City of Ryde Submission

Parramatta Light Rail – Stage 2 Environmental Impact Statement

Date: 5 December 2022

Melrose Park bridge Current v Alternative PLRS2 route

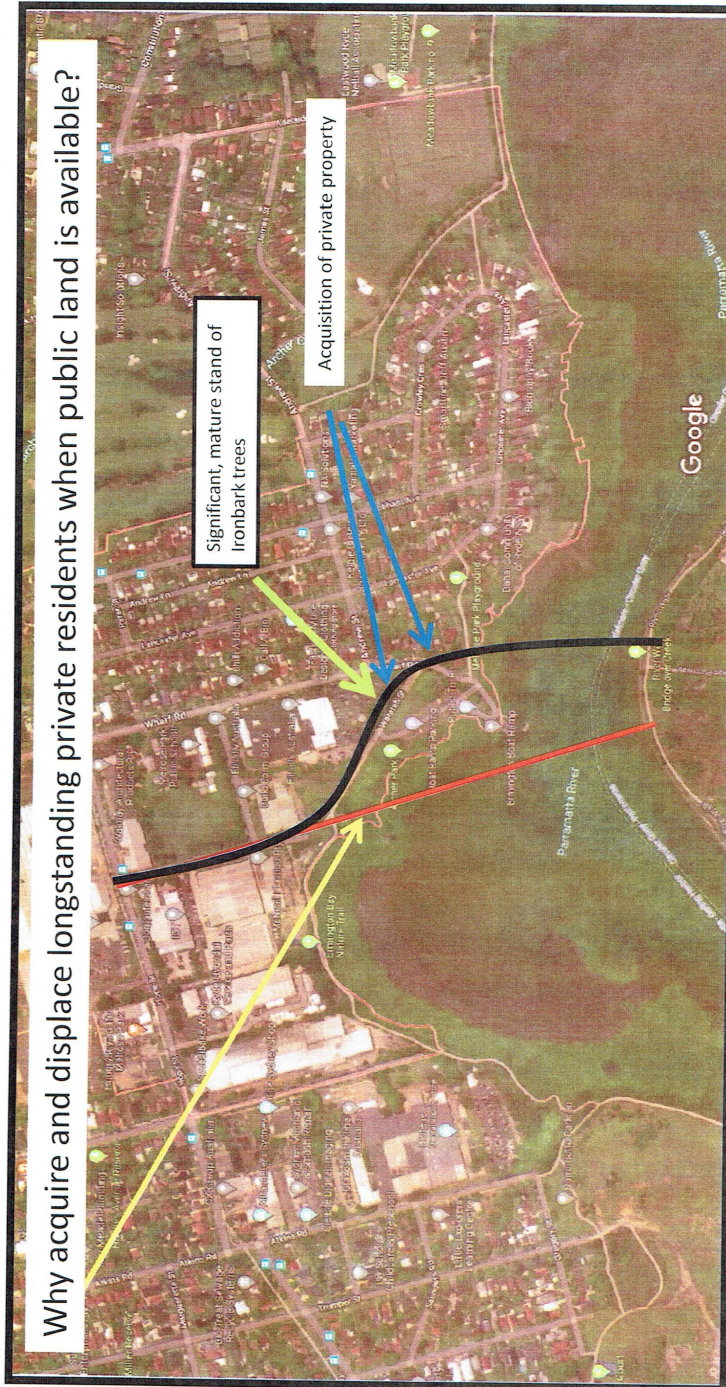
MPRAG have proposed an alternative route that it considers to be more cost-effective, less environmentally intrusive and less disruptive to the existing infrastructure and residential properties in the area.

Please refer to the diagram on the following page provided by MPRAG showing the preferred route by the Group, which traverses through Archer Park.

Alternate route

- No private property acquisition or displacement required
- Shorter route from Hope St to opposite side of river (748m)
- No removal of significant mature trees
- Longer distance from bridge to existing residential houses (163 m)

Current route

- Up to 12 private properties to be acquired and displaced
- Longer distance from Hope St to opposite of river (849m)
- Removal of up to 12 significant mature Ironbark trees
- Closer distance to existing residential housing (64m)

The benefits of this alternative route proposed by MPRAG should be considered and investigated further as the bridgework component of the project progresses.
